# Strategic Planning Committee

## Dorset Council response to consultation on proposed energy recovery facility at Eco Sustainable Solutions, Parley.

**Application 8/21/0207/FUL: Proposed development comprising the installation of a low carbon Energy Recovery Facility for the generation of electricity and heat through a low-emission thermal process using residual waste; including a new administration building and associated car parking area; associated reconfiguration of existing and permitted uses; an increase in permitted waste throughput; landscaping and associated works.**

# Appendix 2: Proposed Site Masterplan

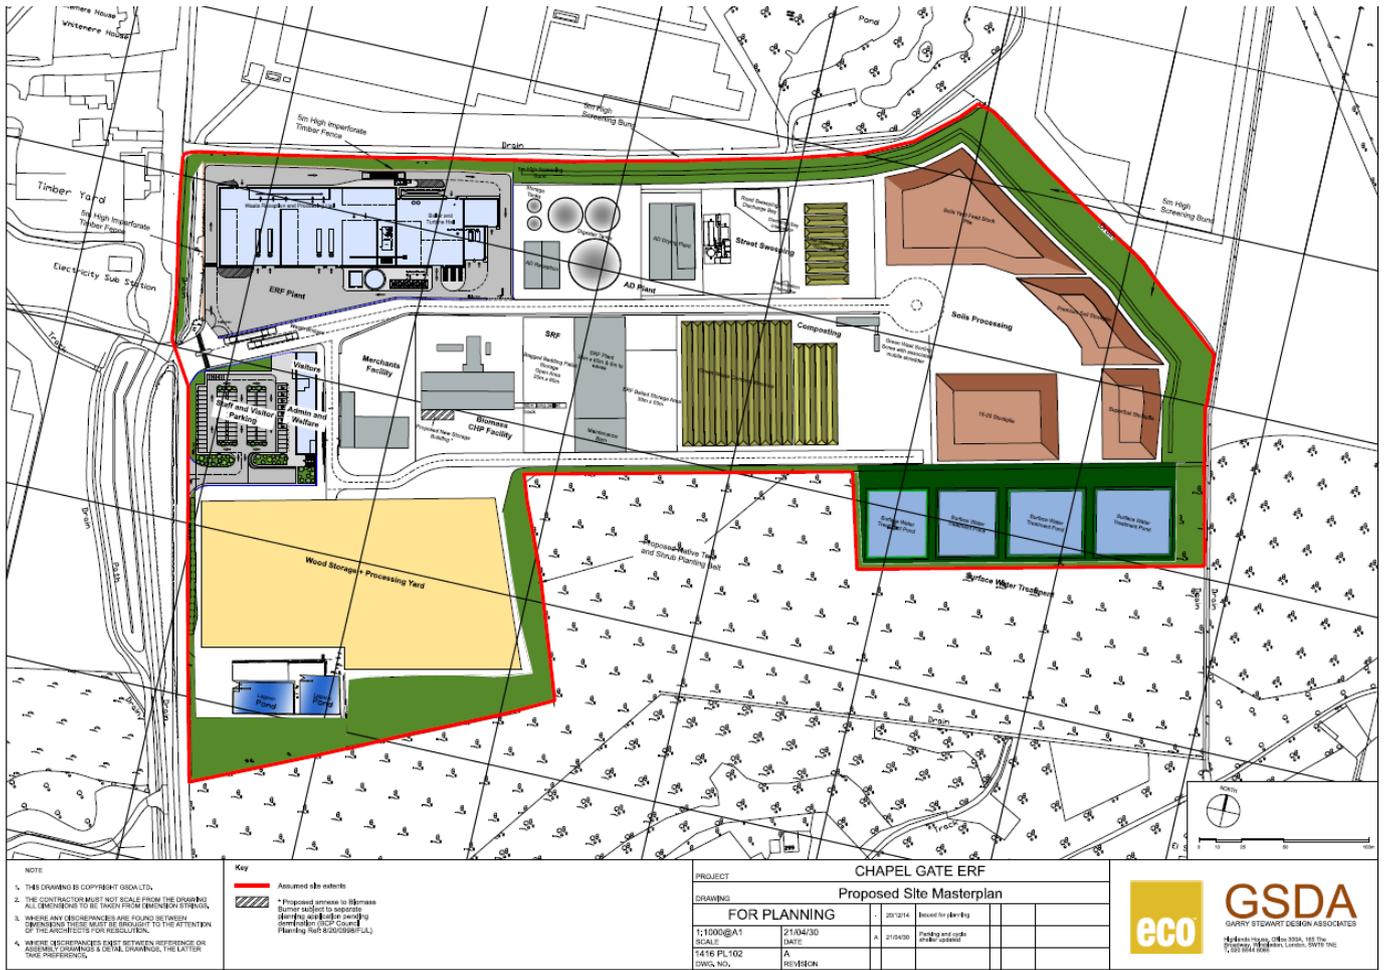
6.4. The proposed Landscaping / External Surfacing Materials Plan DWG. No. 1416 PL105 shows the main addition of the proposed landscape design is in the west framing the car park in front of the proposed Admin and Welfare building. There appears to be minimal landscape mitigation in the rest of the application due to space constraints. Referring to the Adopted Bournemouth, Christchurch, Poole and Dorset Waste Plan 2019 Insert 7 – Eco Sustainable Solutions, Parley. Point 2 asks:

6.5. Given the scale of the ERF development the landscape mitigation appears minor and focused in the red line boundary. I am concerned the proposal is relying predominantly on the existing landscape features and landscape character and adds little additional landscape enhancement or mitigation measures especially to the wider landscape. This does not address the adopted minerals and waste plan [Para 12.109] requirement for the need of a high-quality landscape design within the Green Belt.
